Proposal #26: 1228-22-71, WISC 2021228
North-South Freeway
Capitol Drive to 2100' N of Hampton Ave.
IH-43
Milwaukee County

This is Addendum No.02, which provides for the following:

ADDENDUM NO. 02

1228-22-71

Addendum No. 02
ID 1228-22-71
Added Sheet 64A
April 9, 2021

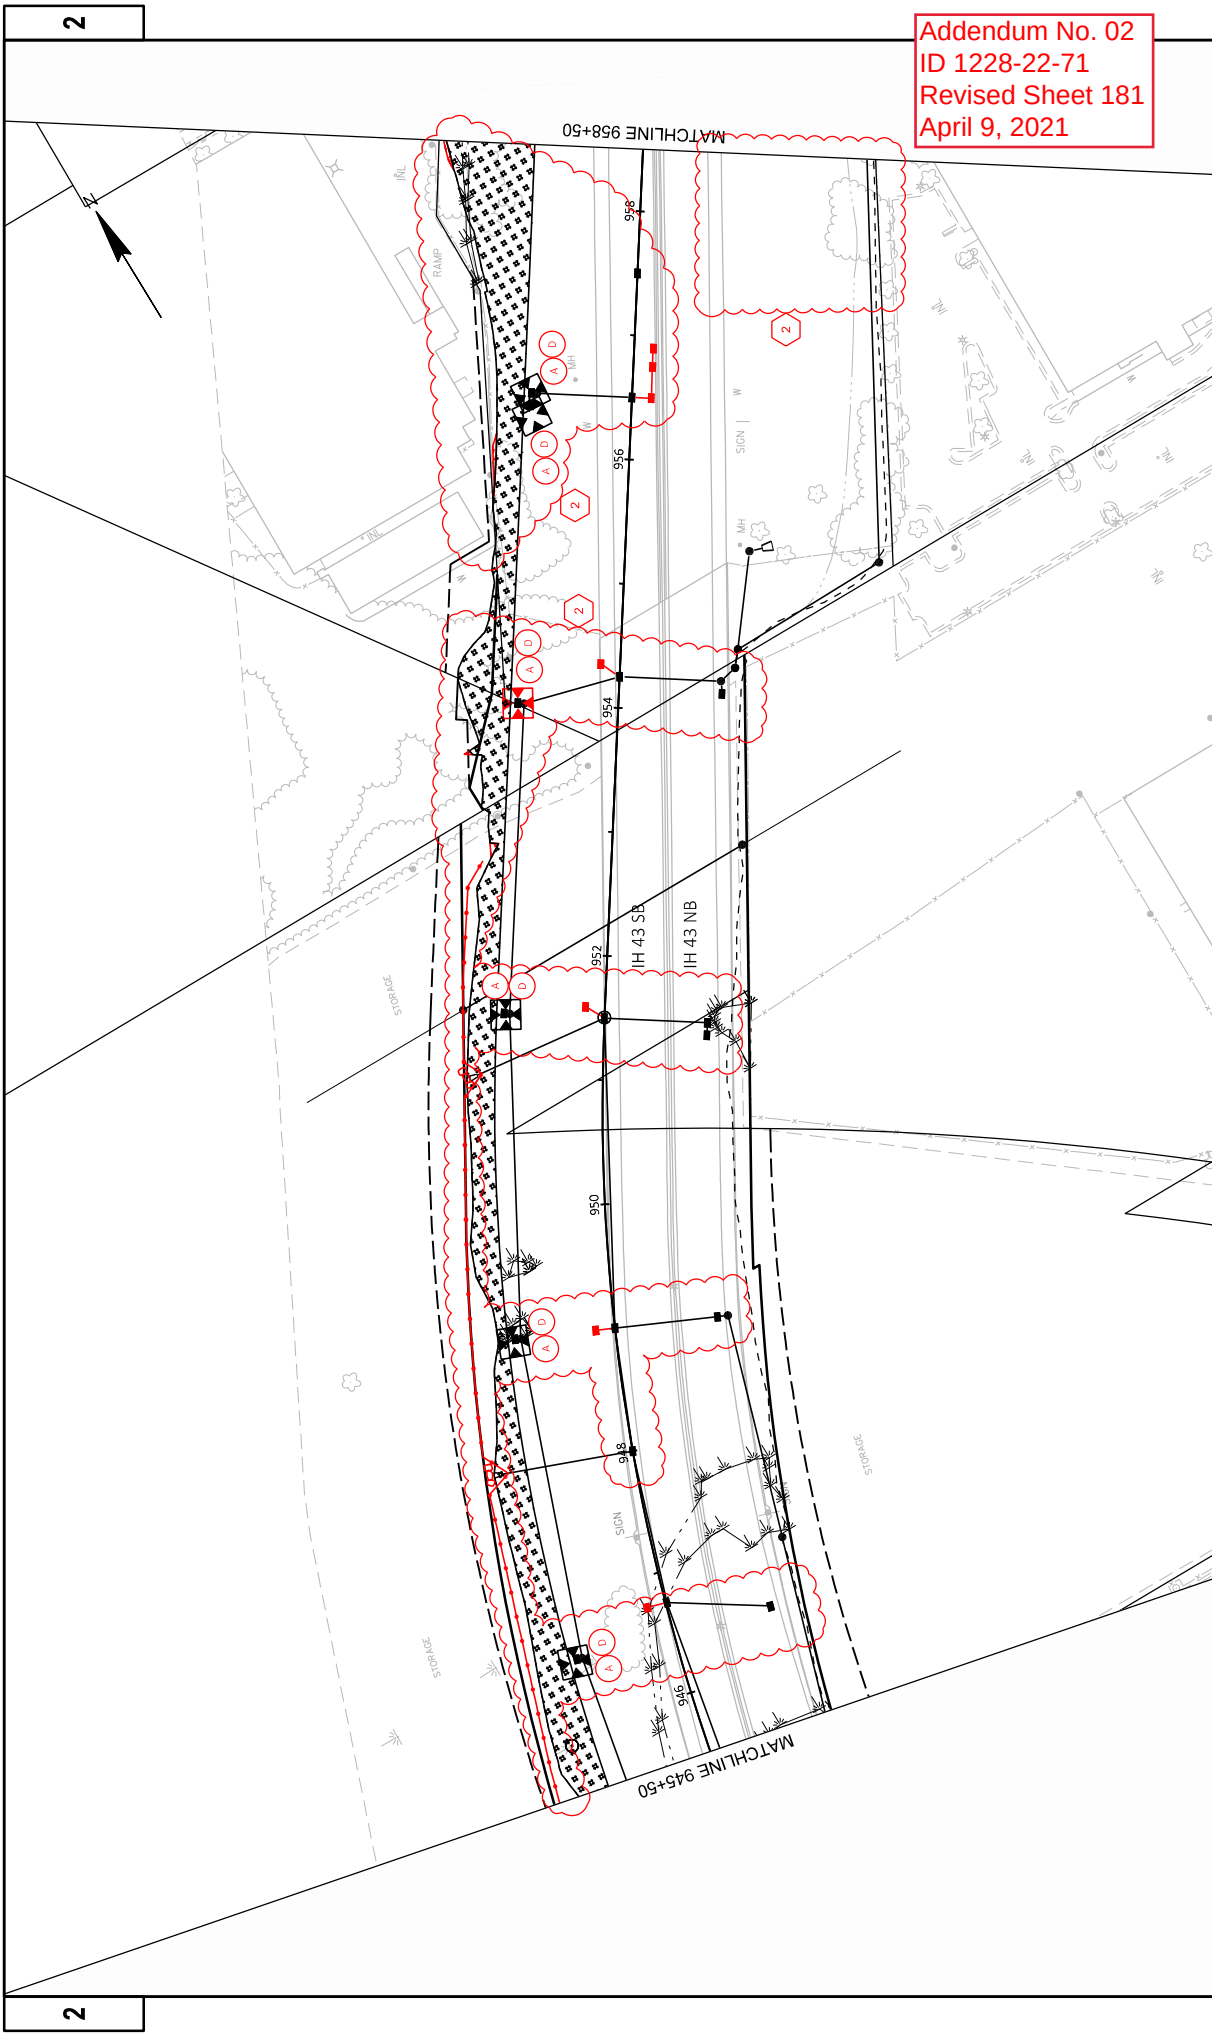
Added Plan Sheets	
Plan Sheet	Plan Sheet Title (brief description of why sheet was added)
64A	Construction Details, Added construction detail for Temporary Settling Basin
179A, 185A, 185B	Erosion Control Stage 1, Sheets added to keep consistent with other stages
509A	Waterway Marker Placement, Added sheet to display placement of waterway markers
580A	Roadway MQ's, Added two new items and Stage 1 MQ table for erosion control items
602A	Roadway MQ's, Added item for anchoring barrier

1. CONTRACTOR SHALL PUMP TURBID WATER FROM EXCAVATION TO EXISTING DITCHES OR TO THE ENCLOSURE PRIOR TO DISCHARGING TO DITCHES/INLETS/WETLANDS OR WATERWAYS.
2. SEDIMENT BAG TO BE PLACED IN A UPR AND VEGETATED AREA OR EQUIVALENT LOCATION APPROVED BY THE ENGINEER.
3. BASIN TO BE KEPT LESS THAN 10% FULL OF SEDIMENT. GEOTEXTILE FABRIC SHALL BE REPLACED AS NECESSARY AND IS INCIDENTAL TO CONTRACT.
4. TEMPORARY SETTLING BASIN AND SEDIMENT BAG TO BE INCIDENTAL TO CONTRACT.
5. SEDIMENT BAG BALES AND FABRIC TO BE REPLACED AS NECESSARY AND IS INCIDENTAL TO CONTRACT.
6. SIZE TO BE DETERMINED BY THE CONTRACTOR AS PART OF THE EOP SUBMITTAL.

Addendum No. 02
ID 1228-22-71
Revised Sheet 181
April 9, 2021

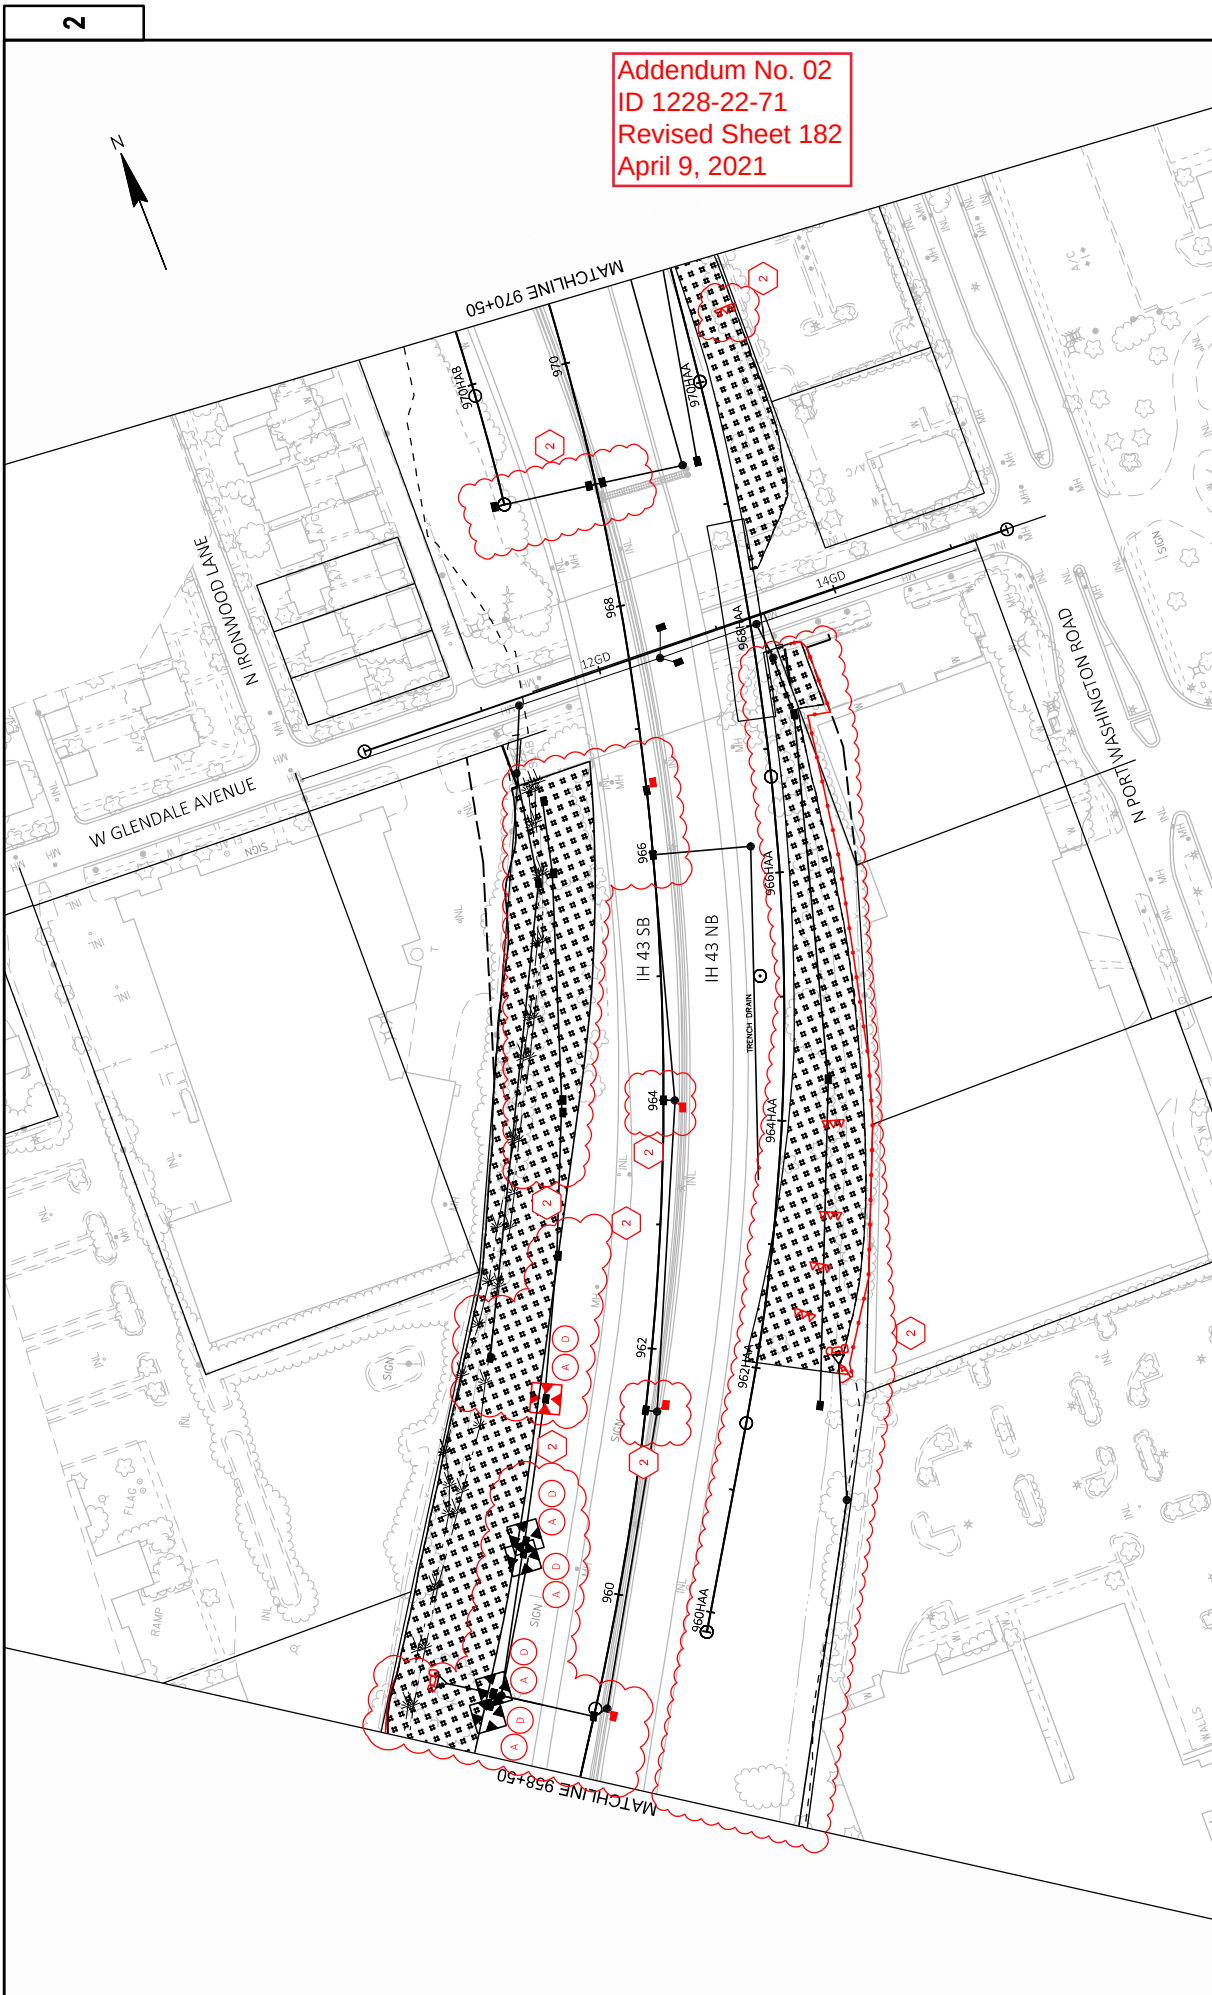
Revised Plan Sheets	
Plan Sheet	Plan Sheet Title (brief description of changes to sheet)
180-194	Erosion Control
361, 363, 364	TC Stage 1
374, 375, 382	TC, Stage 2
402, 403, 407C	TC, Stage 2C1
413, 415,	TC, Stage 2C2

581- 587	Roadway MQ's, Updated erosion control quantities to reflect plan updates
602	Roadway MQ's, Added item for anchoring barrier
604- 605	Traffic Control MQ's, Updated Temp Pavement Markings and added QWS

Addendum No. 02
 ID 1228-22-71
 Revised Sheet 428
 April 9, 2021

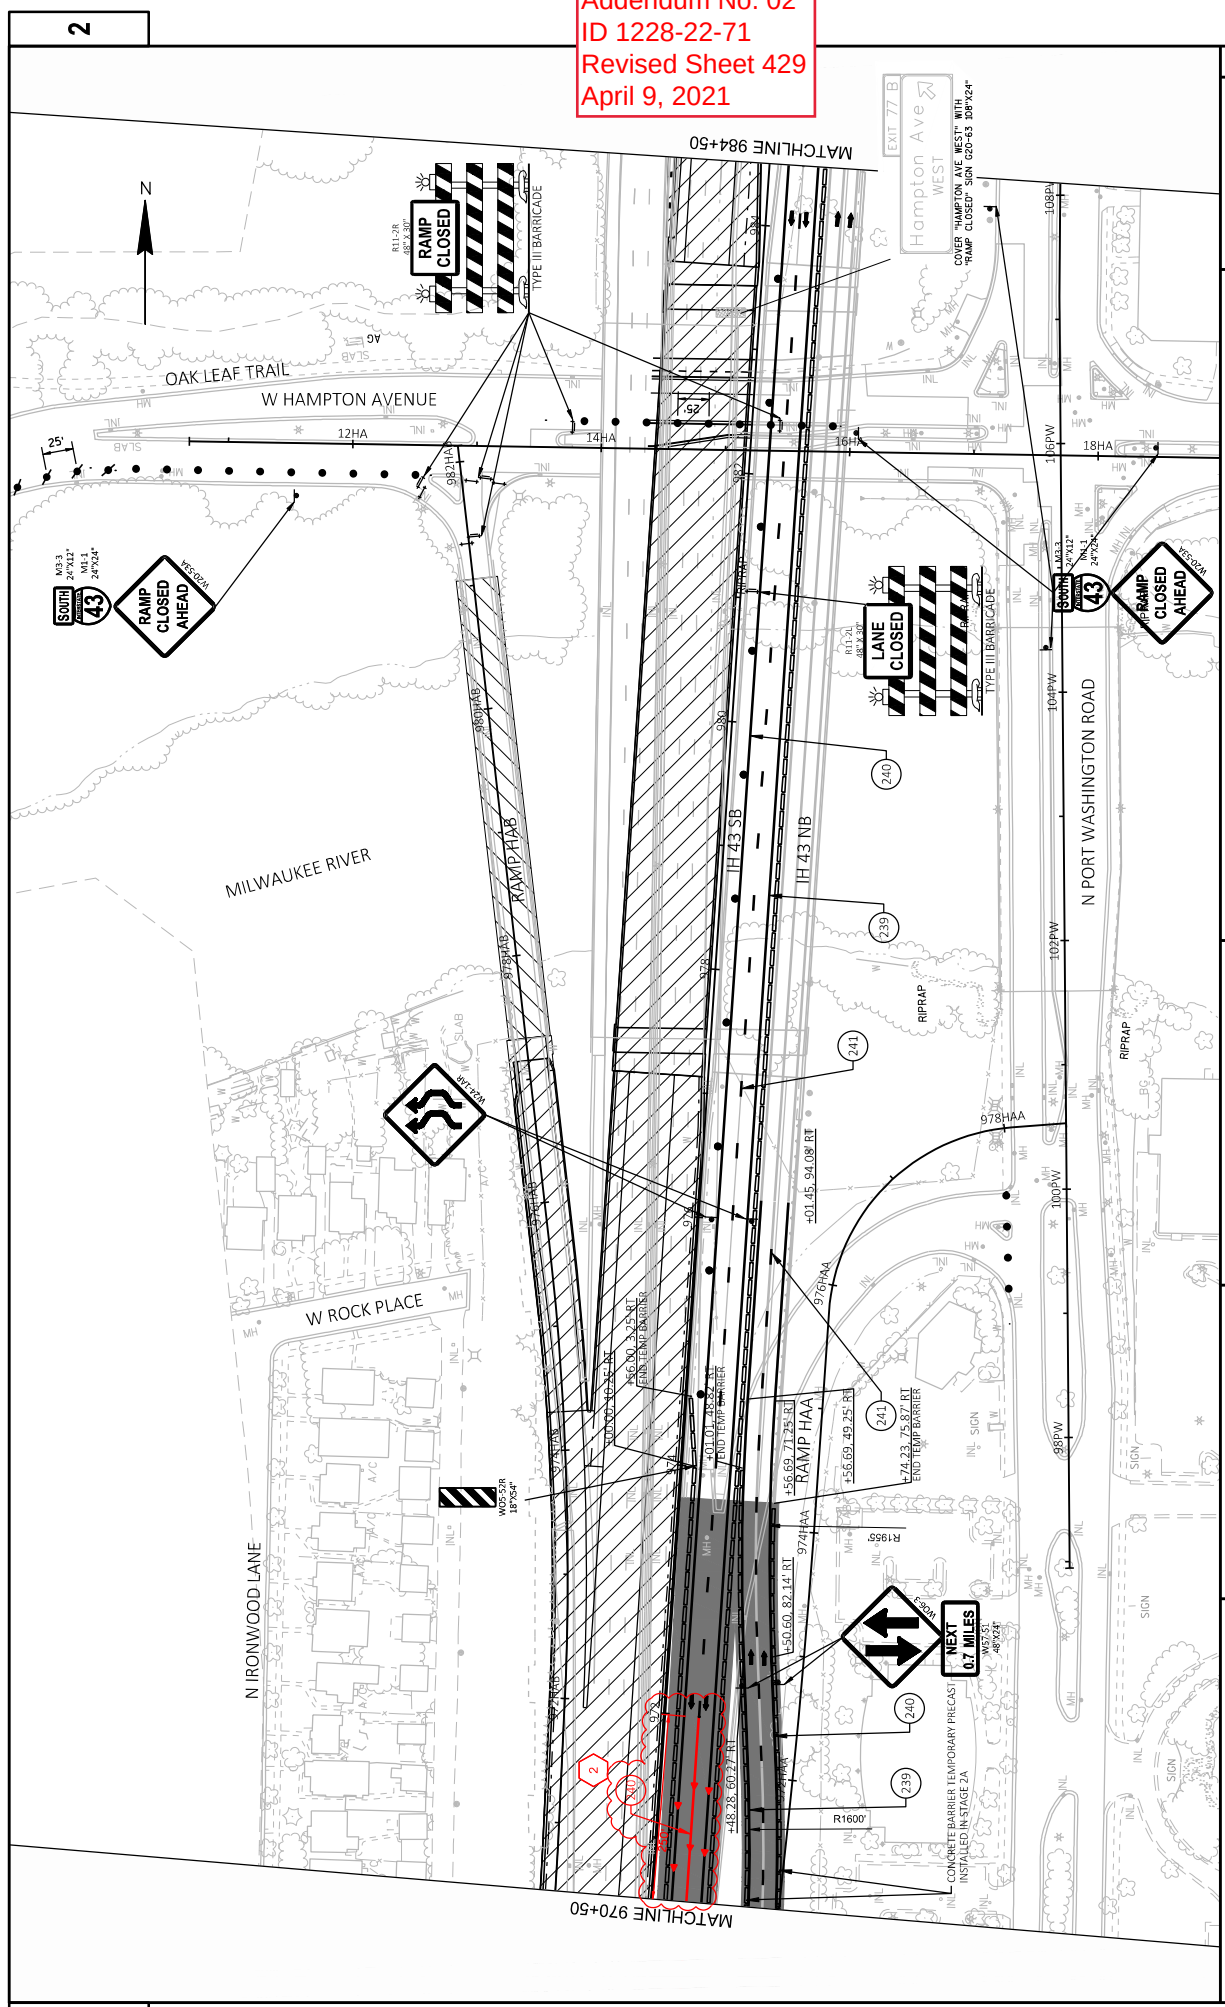
416, 420C	
425- 429, 431- 433, 433C	TC Stage 2D, Added Note for QWS
438- 439	TC Stage 3A, Added raised pavement markers and solid centerline
441- 442	TC Stage 3A, Added raised pavement markers and solid centerline
446C	TC Stage 3A, Added Note for QWS
453	TC Stage 3B, Added raised pavement markers and solid centerline
460C	TC Stage 3B, Added Note for QWS
474	TC Stage 4, Added Note for nighttime closure on Ramp GBA2
477- 478	TC Stage 4, Added raised pavement markers and solid centerline
483- 484	TC Stage 4, Added raised pavement markers and solid centerline
485C	TC Stage 4, Added raised pavement markers and Note for QWS
498C	TC Stage 5, Added Note for QWS
507- 509	Temporary Causeways, Updated typical width of causeway and removed fingers to Ramp HAB
566	Roadway MQ's, Updated earthwork table to include the Oak Leaf Pond, and corrected calculation error.
567- 568	Roadway MQ's, Updated quantities to be included in Ton item
